Duke Energy

Subject: Oconee Nuclear Station
Docket Numbers 50-269, 270, and 287
Supplement to License Amendment Request for Full-
Scope Implementation of the Alternate Source Term
Technical Specification Change (TSC) Number
2001-07

Duke Energy Corporation
Response to Request For Additional Information
Approval of Alternative Source Term Implementation

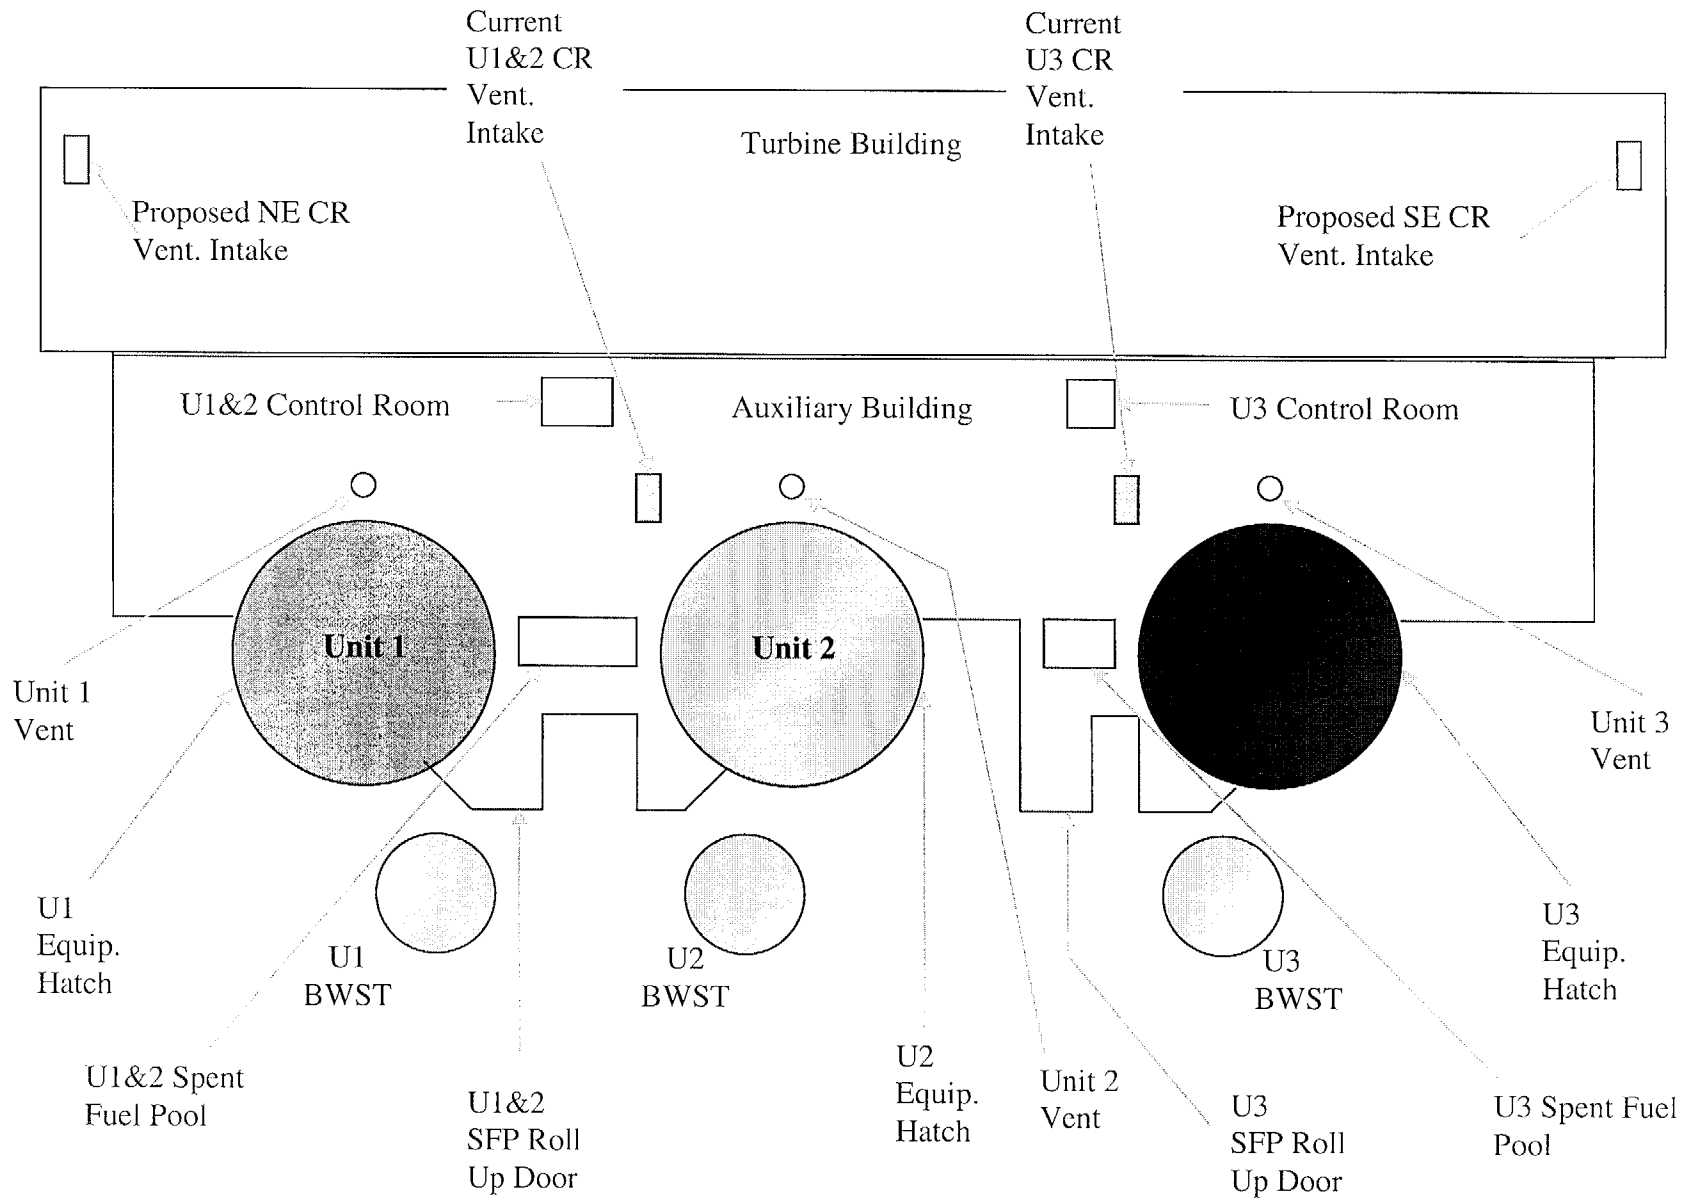
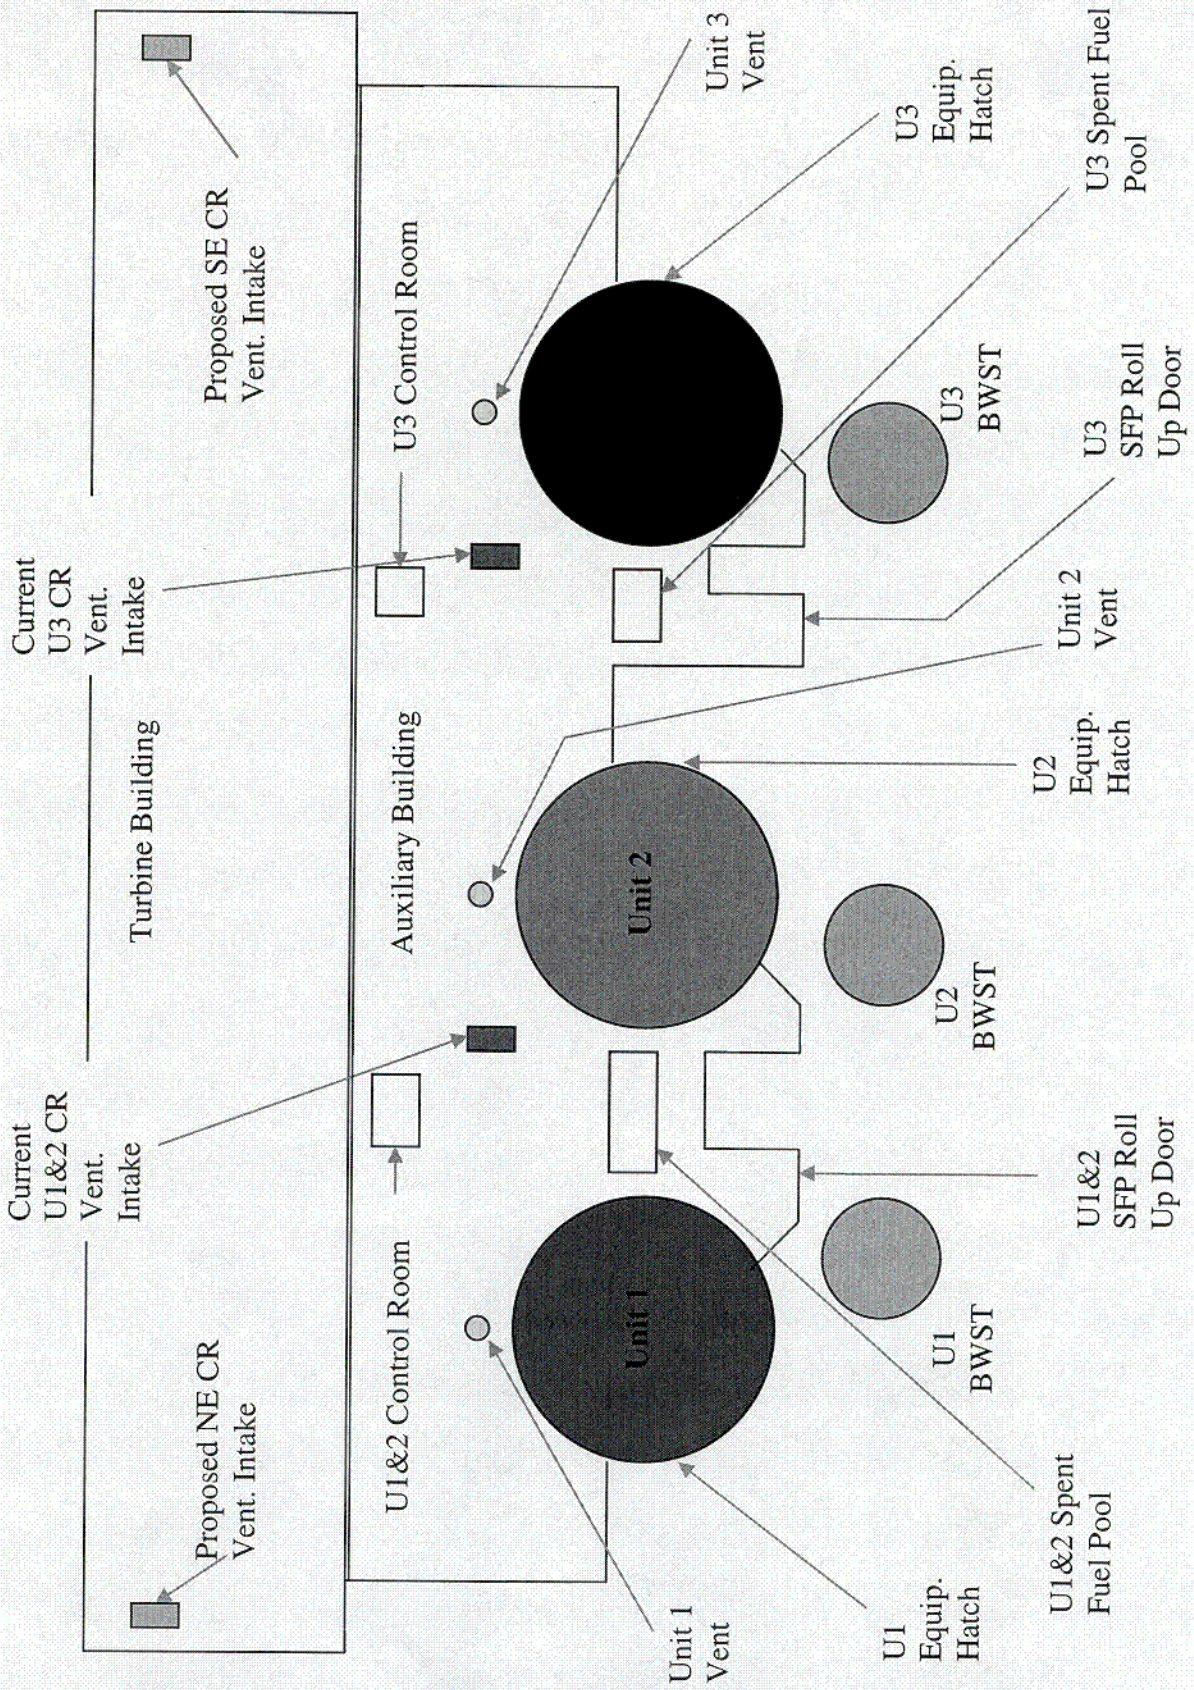
Provide drawings (or sketches) showing containment, turbine building, auxiliary building, fuel building, control room, fuel pool, containment equipment hatch, containment personal air locks, spent fuel pool roll-up door, unit vent, borated water storage tank, current control room air intake, proposed future dual control room air intakes, and source term release points for all 3 units.

The following page contains a sketch which shows layout of site buildings, location of current control room air intakes, proposed future dual control room air intakes, and source term release points for all 3 units. Note that this figure is not to scale.

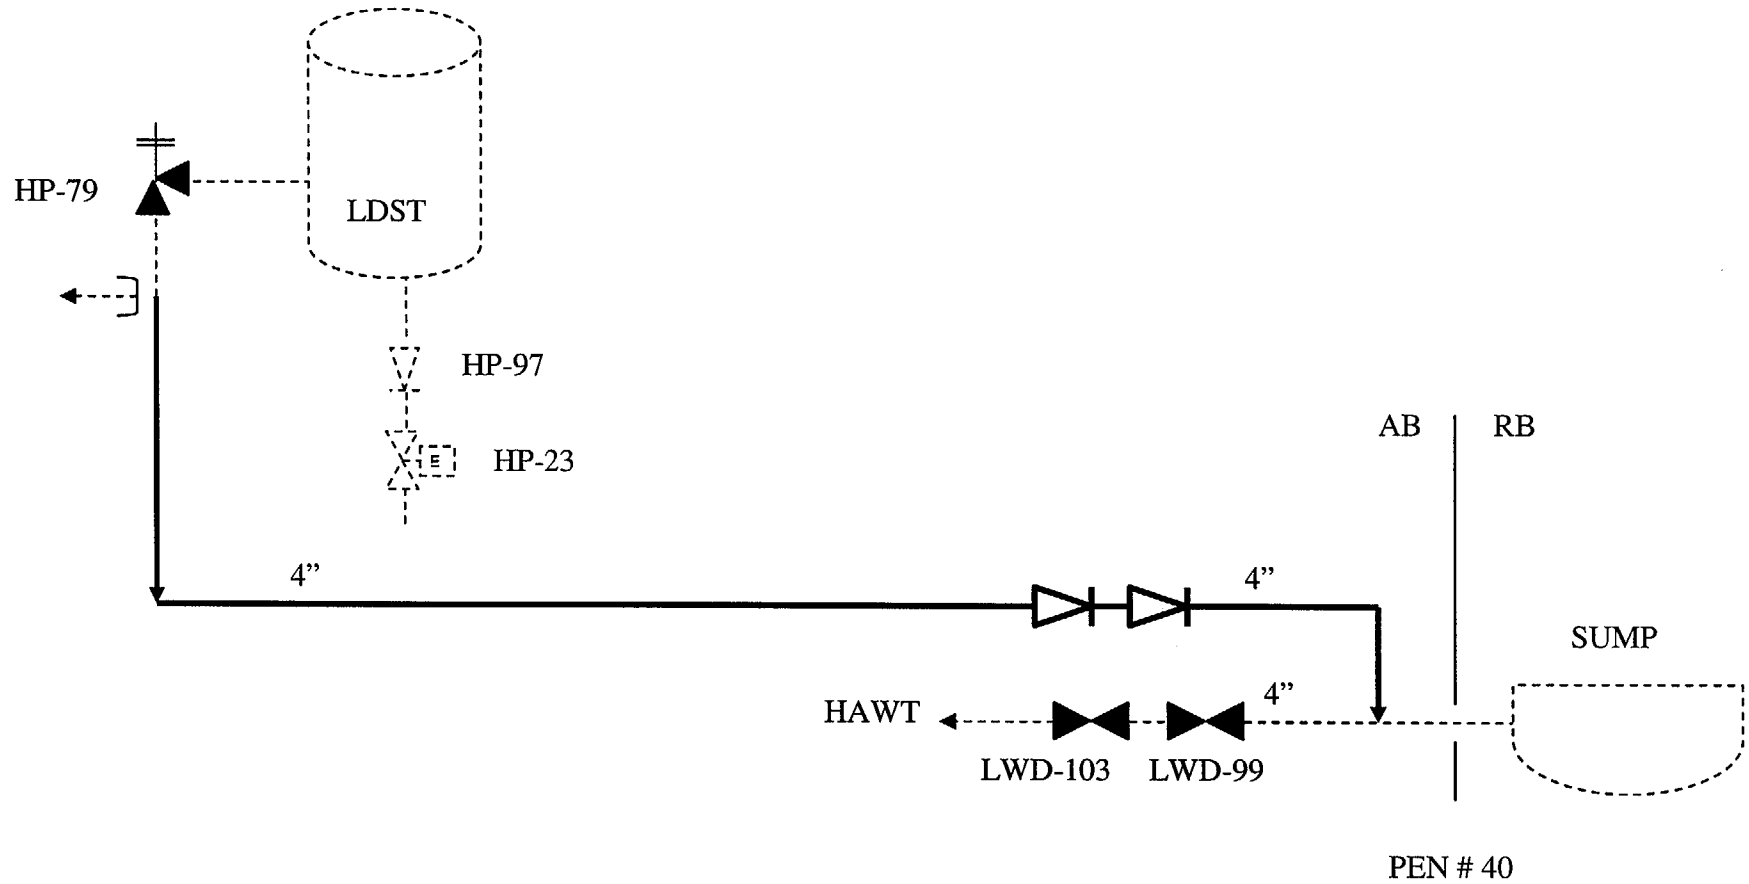
Provide P&ID for the proposed the high pressure/low pressure injection relief valve discharge to the reactor building emergency sump. Provide the schedule for this plant modification as a license commitment.

As stated in our October 16, 2001, submittal, the Letdown Storage Tank (LDST) relief valve, HP-79, currently relieves to the RC Bleed Hold-up tank, which is located in the Auxiliary Building. A modification is being implemented to route the LDST relief valve discharge to the Reactor Building Emergency Sump (RBES). The engineering design work is still in progress. The attached drawing illustrates the conceptual design. Relief valve HP-79 can be pressurized due to leakage through the following valves:

- LP-15 and LP-16 (LPI pump discharge to HPI pump suction)
- HP-23 (LDST outlet header isolation valve)
- HP-97 (LDST outlet header check valve)

Operator actions in the Emergency Operating Procedure currently prevent overpressurization of the LDST. However, Duke believes it is prudent to improve the design such that it is passive in nature. This will simplify operator actions and ensure that any leakage to the LDST is prevented from creating an offsite dose concern in that it will be routed back into the Reactor Building. This design change improves defense in depth in terms of eliminating a potential dose release pathway.

Oconee LBLOCA Sump pH Response

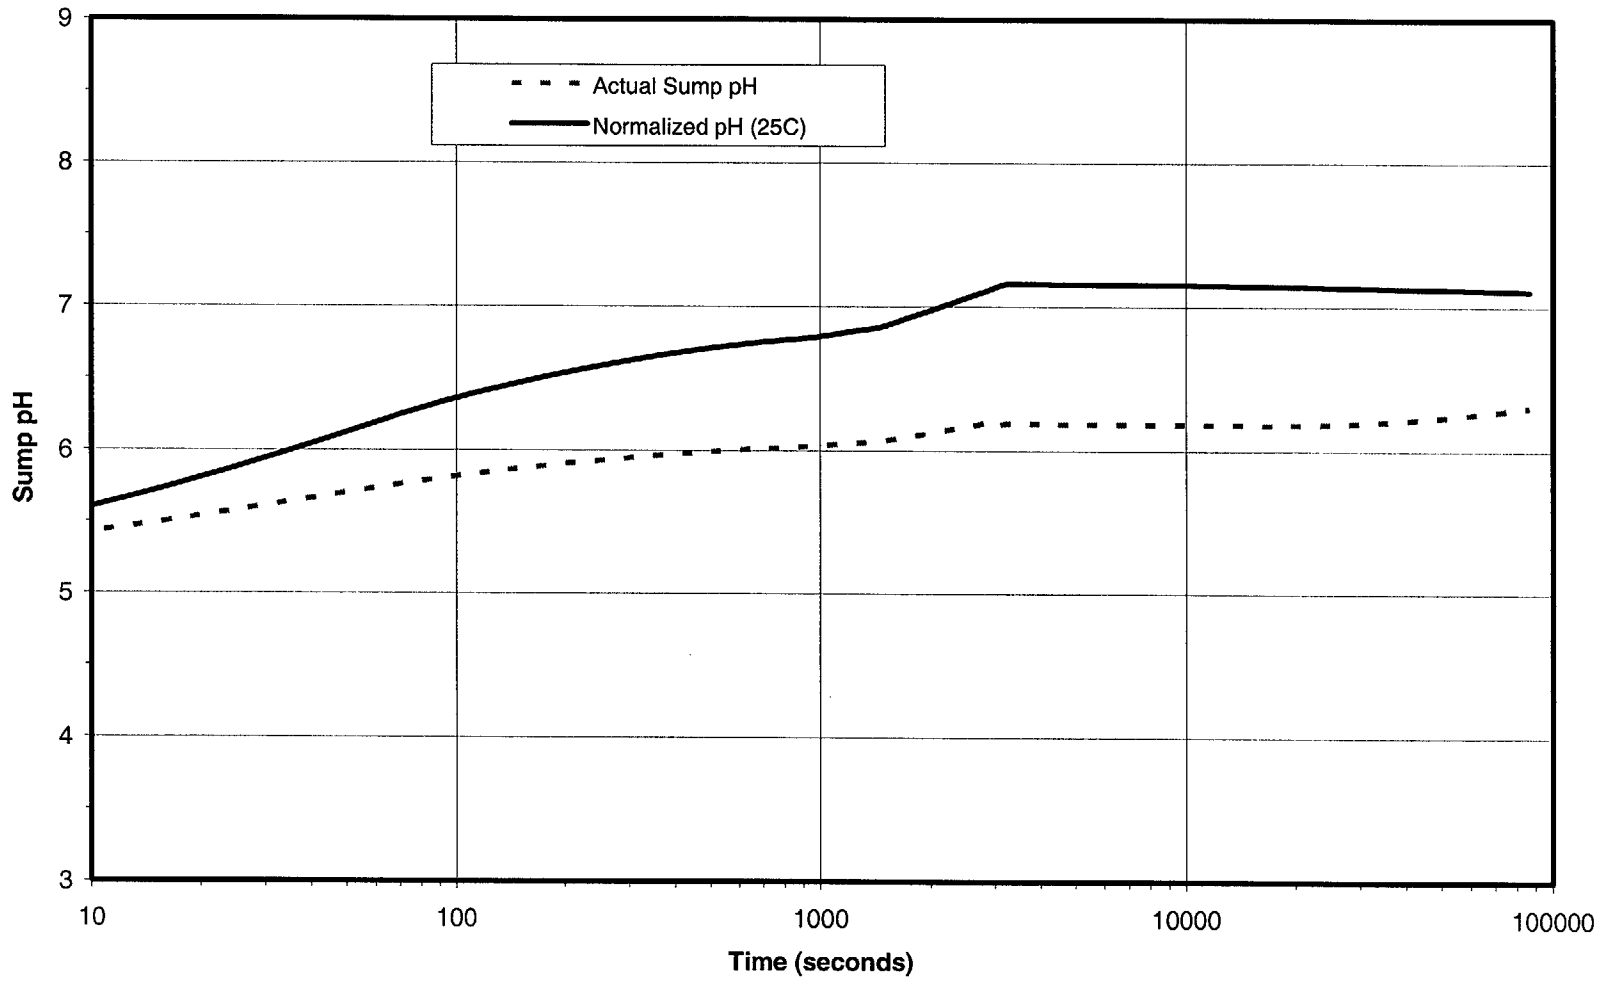
In page 10 of Attachment 3, you stated that the new passive caustic addition system will contain solid caustic or trisodium phosphate. Provide reactor building sump water pH transient calculation for the entire duration of the postulated LOCA addressing the amounts of chemical to be used, initial water pH value, water volume, chloride-bearing cable inventory, acid generation rates, radiation dose profiles, and iodine re-evolution. Provide the schedule for this plant modification as a license commitment.

The containment dose in the Reactor Building following an accident is based on data in the ONS post-accident shielding calculation. An equation representing this time dependent dose for the first 24 hours after an accident is:

$$D(t) = (3.89 \times 10^{-14}) \cdot t^3 - (7.026 \times 10^{-9}) \cdot t^2 + (5.34 \times 10^{-4}) \cdot t + 6.01 \times 10^{-1} \text{ [Mrads]}$$
